RE: Data Response, Set 1D (Optimization)
Ivanpah Solar Electric Generating System (07-AFC-5)

Ivanpah Solar Electric Generating System (ISEGS)

Data Response, Set 1D

**(Response to Data Requests: Project Description, Air Quality,
Biological Resources, Land Use, Soil & Water, and Visual
Resources)**

FIGURE DR44-1
TRAILS
 IVANPAH SOLAR ELECTRIC GENERATING SYSTEM

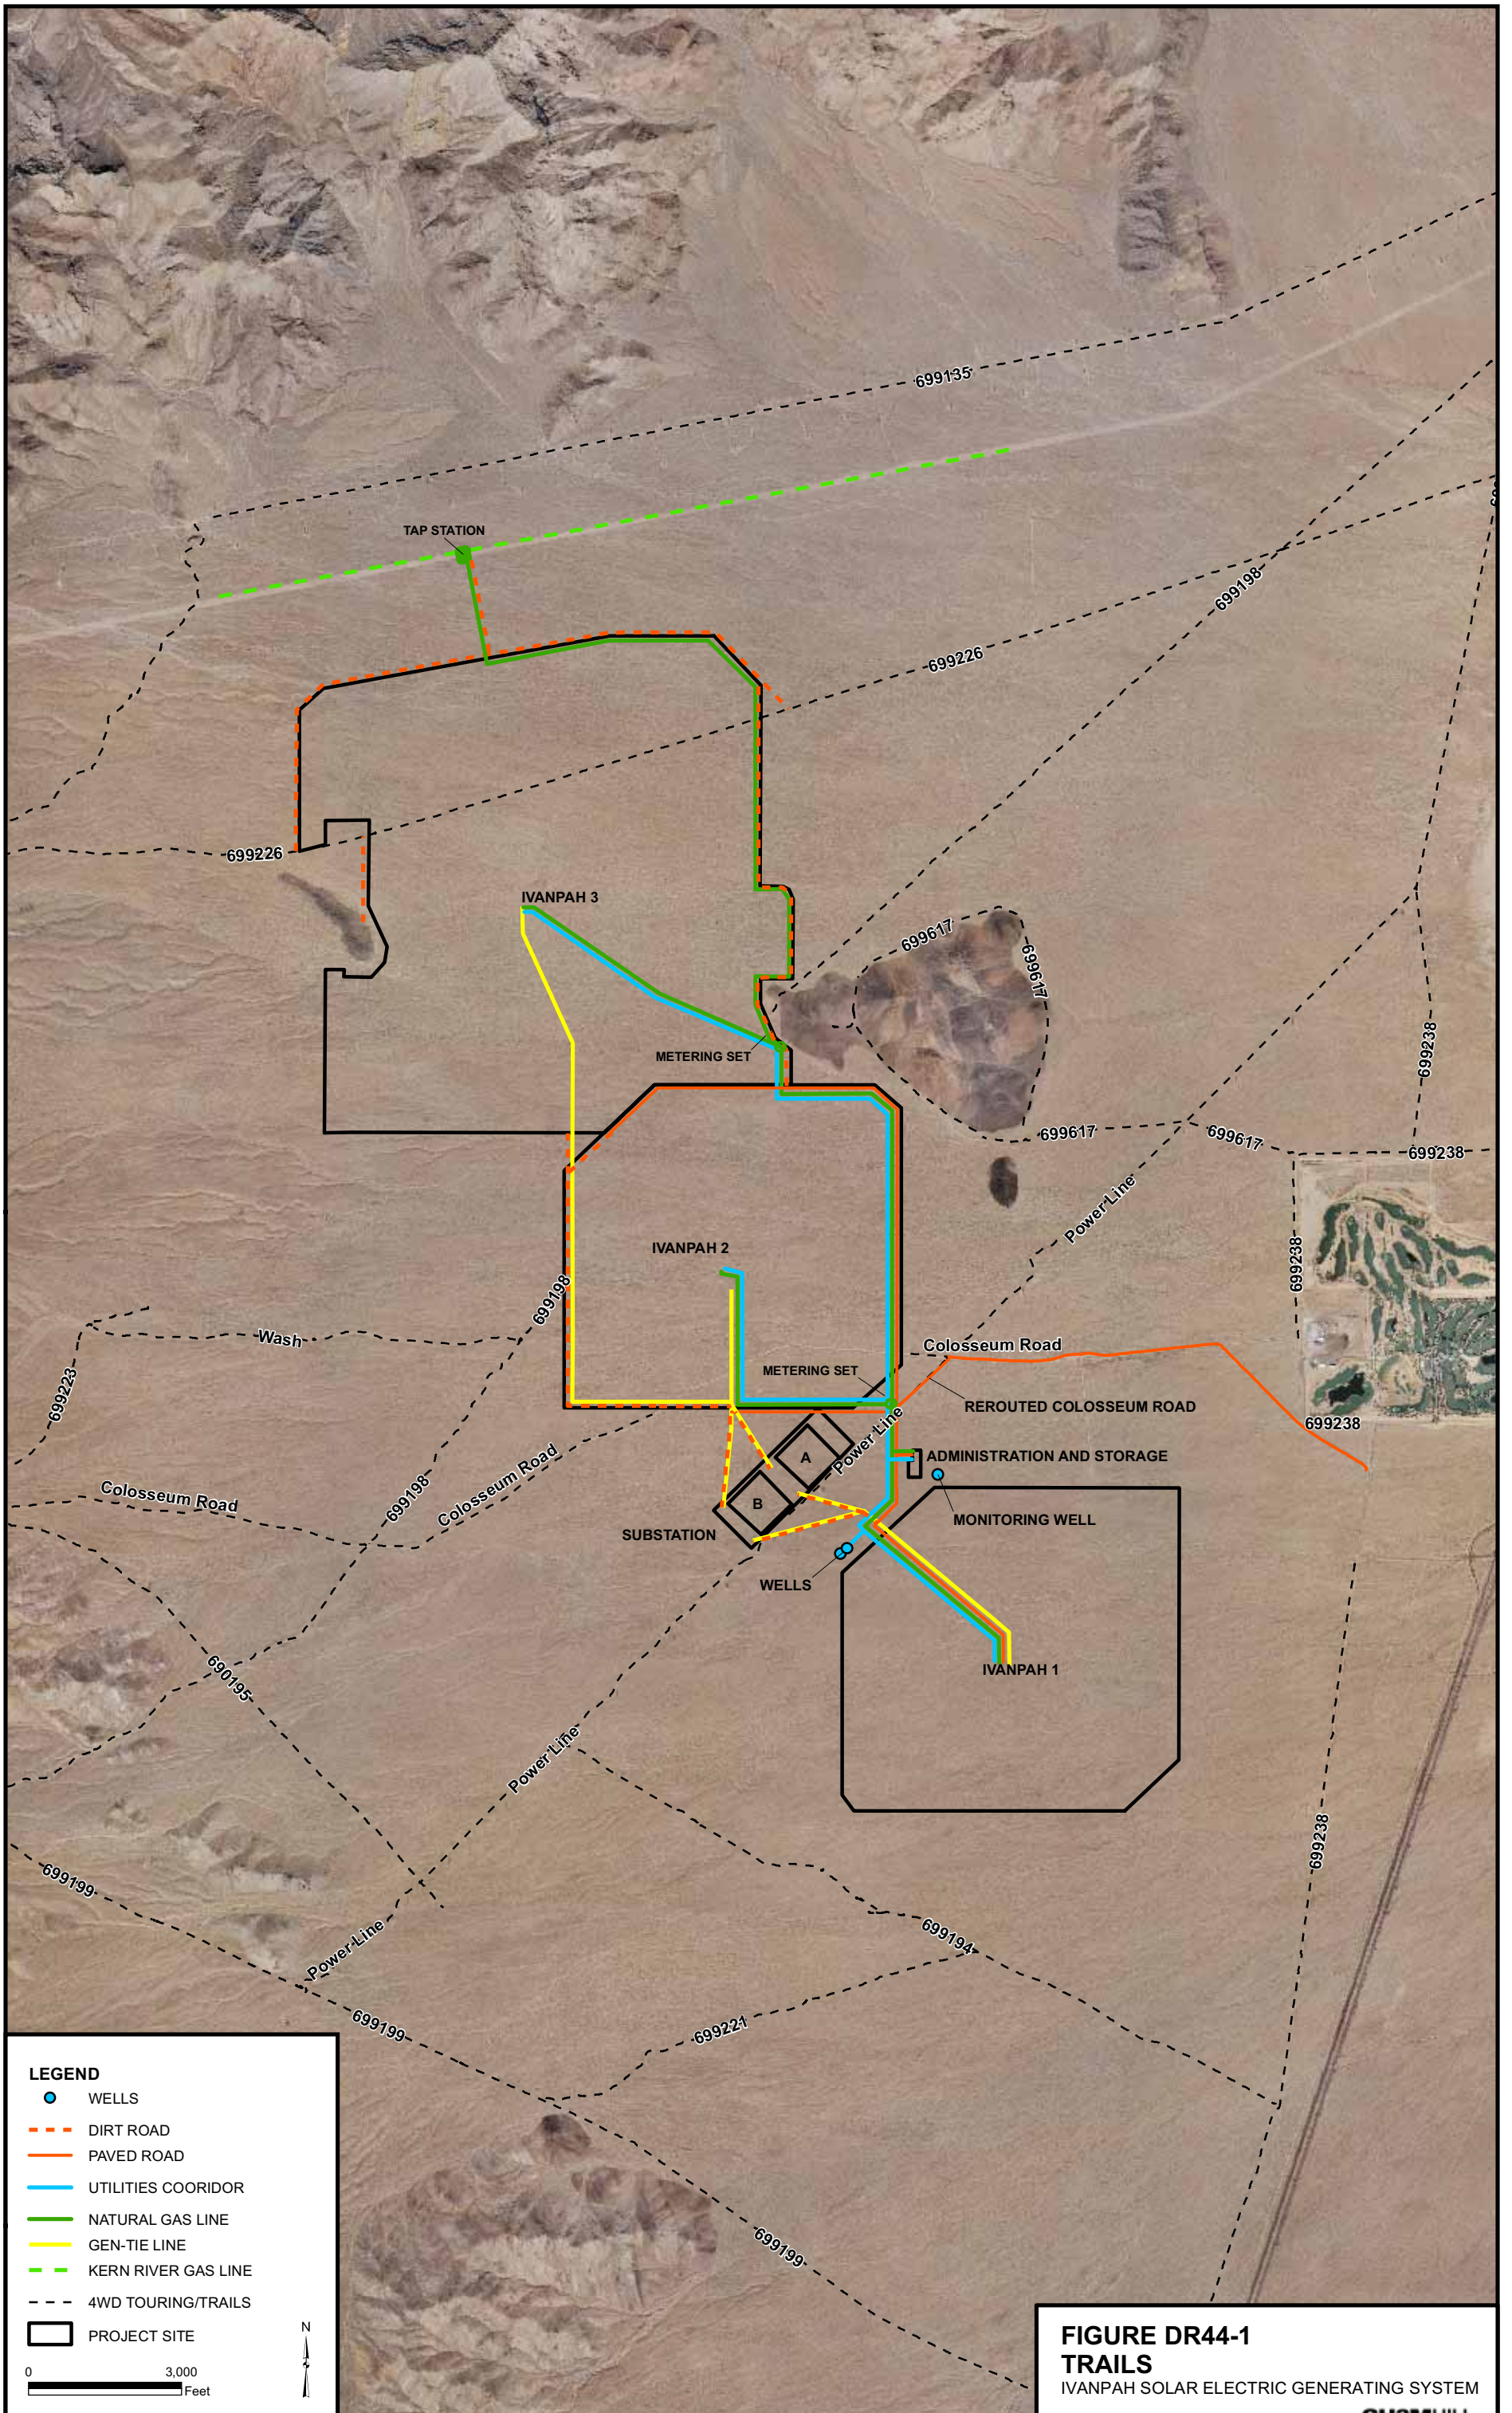
44. Provide a complete inventory and assessment of travel routes within and adjacent to the planning area using the California BLM Route Inventory Data Dictionary.

Response: The Applicant was provided electronic files from BLM of catalogued trails within the vicinity of the Ivanpah SEGS. These trails are shown on Figure DR44-1. Table DR44-1 identifies each trail shown in Figure DR44-1 and describes whether the trail will remain open or whether a modification is required. As previously committed by the Applicant, travel routes in the area of the Ivanpah SEGS that would be disturbed through implementation of the three phases of the project, would be addressed in a Trail Plan that will be developed in coordination with BLM. The purpose of the Plan will be to avoid or mitigate potential impacts on these existing routes. This Plan will also identify fencing, gates, dust abatement and restoration measures that would be taken to manage the use of the routes requiring modifications to accommodate the development and operation of the Ivanpah SEGS. The modifications and the Trail

Response: As shown on Figure DR44-1 and described in Table DR44-1, there are 18 trails located in the vicinity of the Ivanpah SEGS and only three of these trails would require modifications to accommodate development of the facility. All of those trails will be rerouted either around or through the project. It is planned that these routes would remain open during construction of the respective phases.

Response: As shown on Figure DR44-1 and described in Table DR44-1, only three trails would require modifications to accommodate development of the Ivanpah SEGS. There are three trails requiring re-alignments to accommodate the facility, but no closures will be required for any portion of these trails. Trail 699226 located on the north side of Ivanpah 3 would be re-aligned along the north side of Ivanpah 3. Trail 699198 would be realigned to pass between Ivanpah 2 and 3. The Colosseum Road Trail would also require a re-alignment along the southern boundary of Ivanpah 2.

Response: As shown on Figure DR44-1 and described in Table DR44-1, all of the trails in the vicinity of the Ivanpah SEGS will remain open to the public. Of the 18 trails, only three will require modifications to accommodate the facility. Unless temporary closure is required during construction of the rerouted trail, all will remain open with no impacts to trail users. At most, only one trail will be temporarily closed at any one time.

FIGURE DR66-1
CONSTRUCTION LOGISTICS AREA
 IVANPAH SOLAR ELECTRIC GENERATING SYSTEM

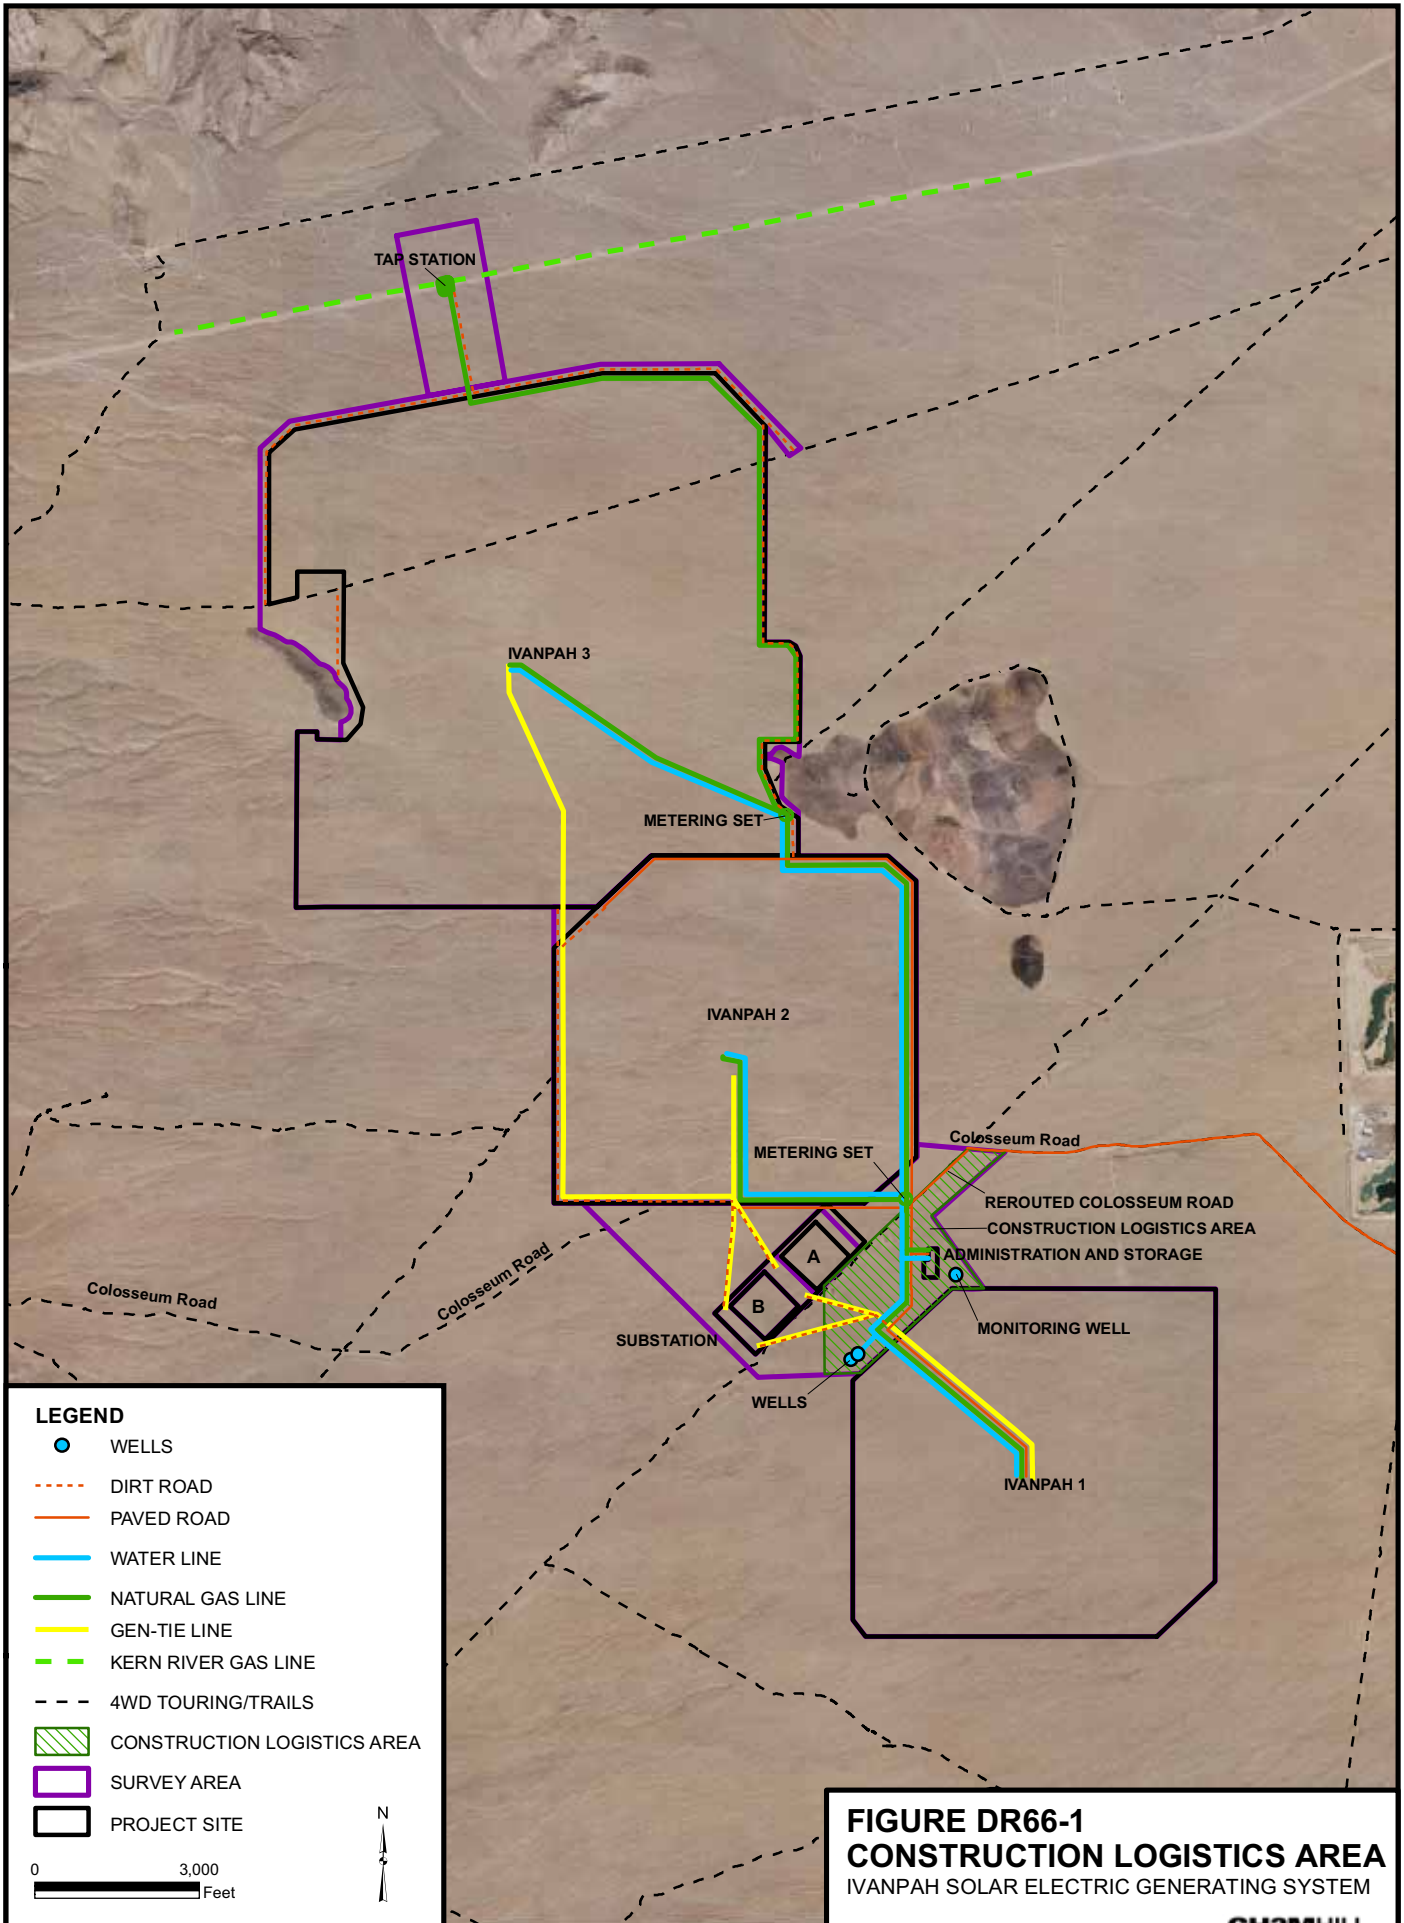
acres). They will be located in the Construction Logistics Area shown in Figure DR66-1, which comprises about 120 acres.

FIGURE 5.13-10bR
SIMULATED VIEW OF IVANPAH 2
AND 3 FROM KOP 2 (HOLE 8)
IVANPAH SOLAR ELECTRIC GENERATING SYSTEM

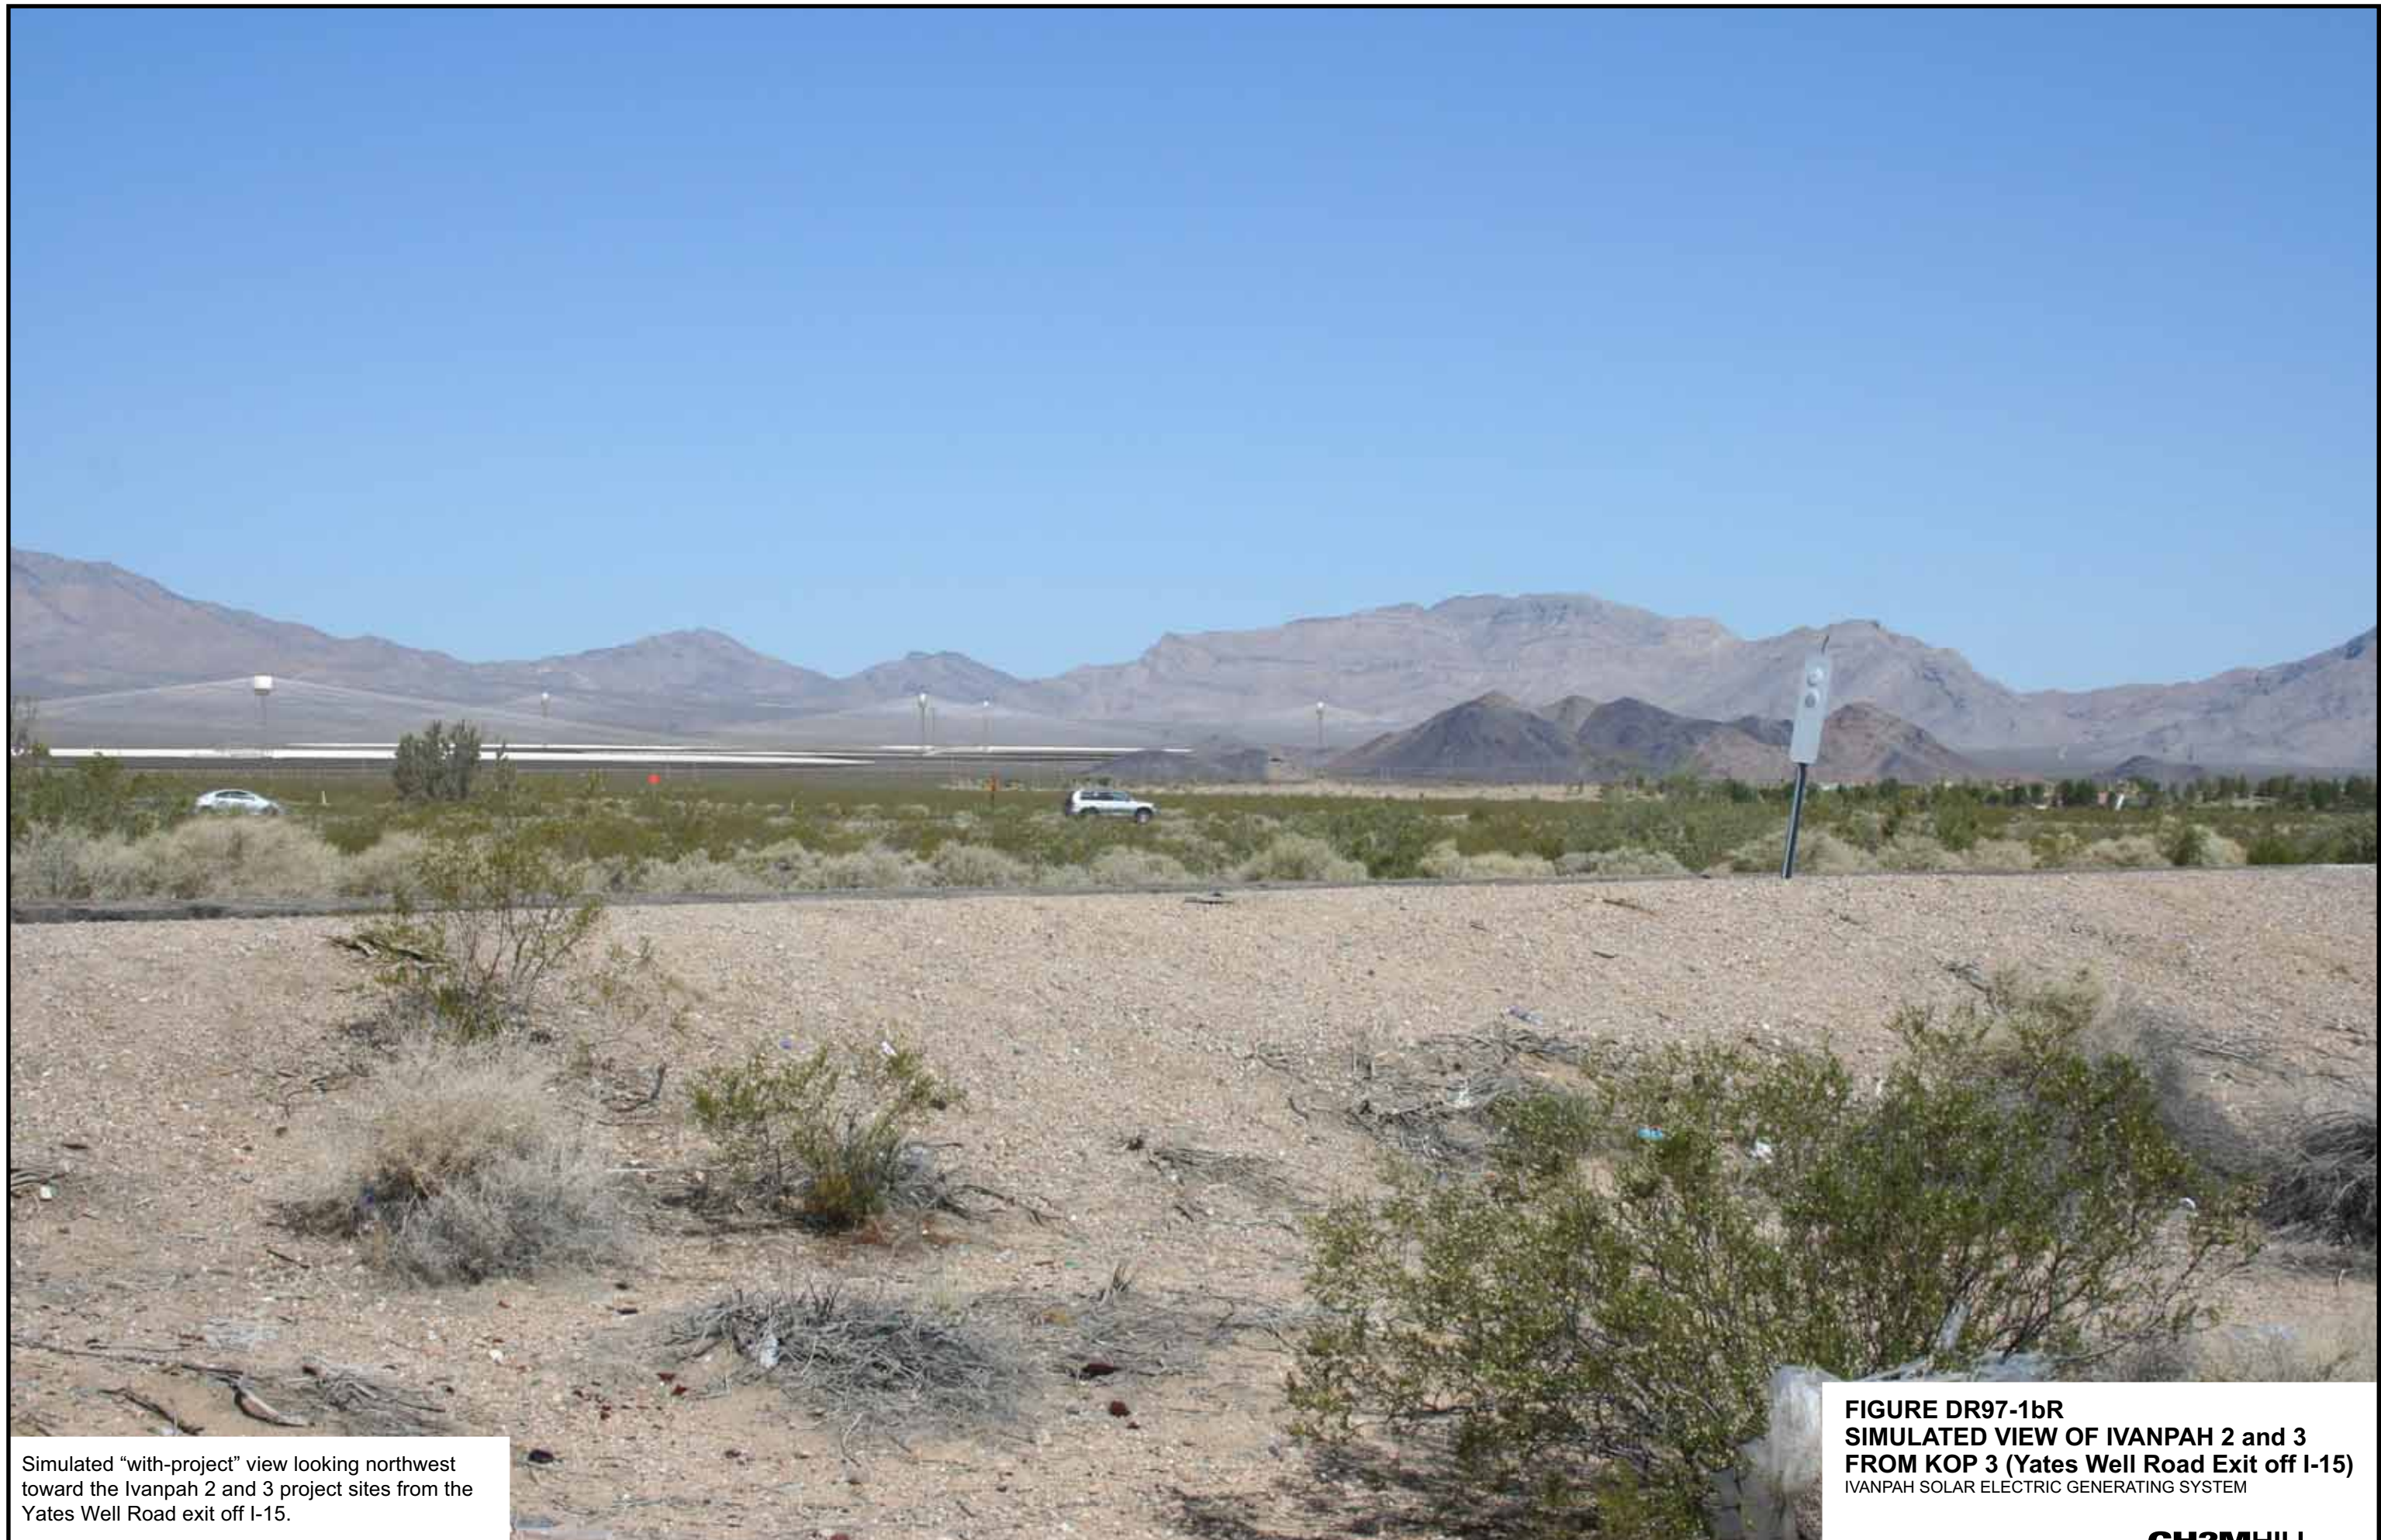
KOPs 2 and 3 (Figures 5.13-10bR and DR97-1bR, respectively) show views of Ivanpah 2 and 3. Figure 5.13-10bR shows the KOP 2 view of Ivanpah 2 and 3 from the Primm Valley Golf Club. When compared to the previous project configuration showing the many vertical structures (Figure 5.13-10b previously submitted in the AFC), the project optimization has fewer structures, but has a taller power tower with greater mass and a larger heliostat field, making them more visible from this location. In comparing both project designs, there is no difference in the visibility of the receiver structures from this distance.
